MICROLIGHT AIRWORTHINESS APPROVAL NOTE

MAAN NO: 2336

TITLE: Microlight Airworthiness Approval Note 2336: Shadow Fuel Tank Deterioration

Reference: BMAA Service Bulletin 2336 Issue 1
Title: Fuel Tank Deterioration
Applicability: All BMAA-administered Shadows
Author: Adrian Jones, Design Approval Engineer, BMAA
Effective date: 21 March 2011
Classification: Essential

Figure 1: Shadow Fuel Tank Construction

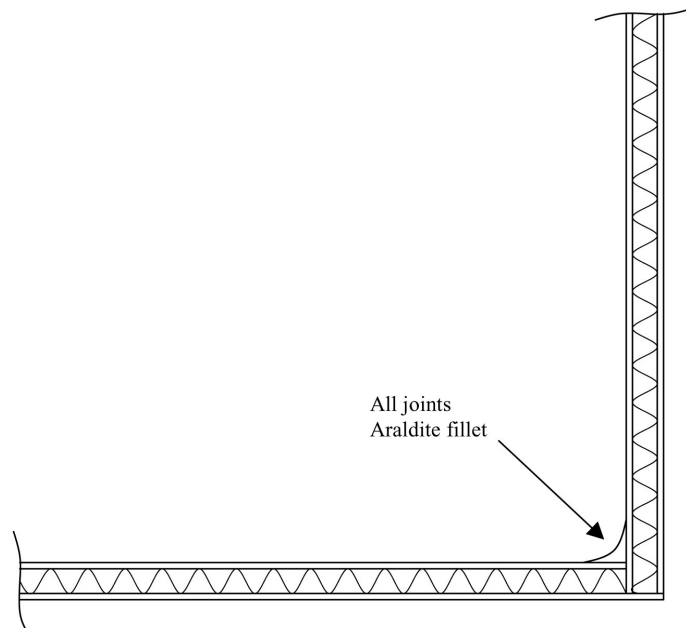
They are constructed from flat 1/8" thick panels, rebated and bonded together at their edges with epoxy. Figure 1 shows a typical edge joint showing a neat fillet of epoxy. After assembly, but before the top is bonded on, the interior of the tanks is coated with a thin layer of epoxy. The fuel outlet hole is then screened by a plastic 'tea strainer' bonded onto the floor of the tank. After bonding on the top a small amount of epoxy is poured into the tank to coat the top panel. It is not possible to neatly fillet the top edge joints as with the rest of the tank.

In a number of examples the tanks have developed leaks at the bonded edges. Also fragments of epoxy have been found and the strainer has become dislodged. In one known case the strainer gauze had disintegrated leading to an engine failure, due to debris entering the fuel line. See Figures 2 & 3. Both the main and slipper tanks have been affected.

Within **10 flight hours or 3 months** of the effective date (whichever is sooner), and then at least every **50-flight hours or annually** (whichever is sooner), check that the fuel strainer in the main tank, and the slipper tank if fitted, is intact and bonded in place, and that it is effective at straining out any particles in the fuel. For the main tank, shine an LED torch into the filler neck, but remember to turn it on and off away from the tank to eliminate the possibility of sparks igniting the fuel. For the slipper tank, remove the fuel gauge sender unit and inspect the strainer through the aperture. The aircraft should not be flown if a strainer is not doing its job effectively.

At the same time check for the presence of any particles of epoxy or other debris in either tank. If any are found they should be flushed out with clean fuel until no loose debris remains. Ensure that this is done in an open, well-ventilated area away from any possible source of ignition.
